### Staff Report & Recommendation

### Design Review Board

SUBJECT: DRB17-0161  
**5750 Collins Avenue – Royal Embassy**

The applicant, Royal Embassy Condominium, is requesting Design Review Approval to replace existing concrete balcony railings on all elevations of the building with all clear glass railings.

Details of original glass panel balconies from original Morris Lapidus plans

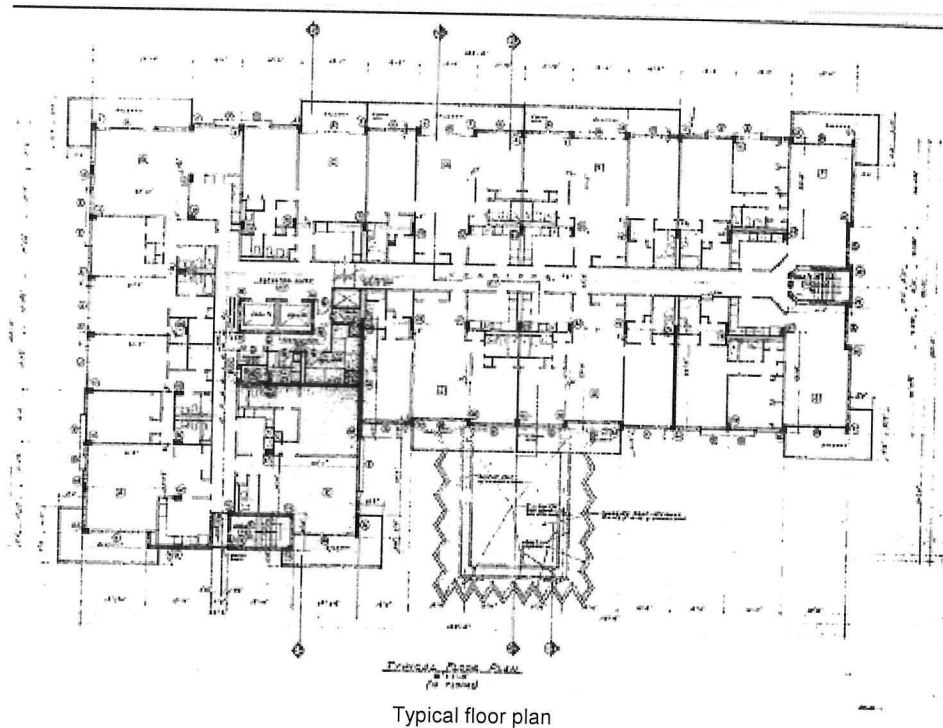
The original design for the Morris Lapidus designed building contained a glass panel system for the long portion of the balconies with smaller concrete portions at the sides and to separate the private balconies from one another's unit.

In 1980, an expansive renovation and improvement project removed the glass panels and replaced those areas with a standard black metal aluminium vertical picket style railing.

Today, the Royal Embassy Condominium is currently undergoing renovations and pursuant to Building Permit BC0616-0732, obtained approval for the removal of the vertical picket style railing and replacement with clear glass balcony railings. Now, to obtain a uniform appearance for the balconies, the Royal Embassy have applied for Design Review approval to remove the

existing concrete portions of the balcony railings and replace same with glass. This alternative will afford uniform views of the waterway and Collins Avenue and create a consistent glass railing system that lightens the load on the balconies for added structural integrity. The total amount of demolition of concrete balconies is minimal in relation to the linear amount of existing glass areas. Since the majority of the concrete walls on the balconies occur on the less visible sides of the north and south elevation, the noticeable effect on the architectural integrity of the Morris Lapidus building will be minimal.

Consequently, staff does not object to the glass railing replacement to the concrete balconies on 130 balconies of the building and recommends approval of the application as proposed.

- b. Fully and carefully designed details for the proposed balconies shall be submitted; the method of railing connection to the slab, as well material finishes and dimensions shall be provided, in a manner to be reviewed and approved by staff.

- c. Color samples for the glass railing shall be submitted for the review and approval of staff.
- d. A copy of all pages of the recorded Final Order shall be scanned into the plans submitted for building permit, and shall be located immediately after the front cover page of the permit plans.
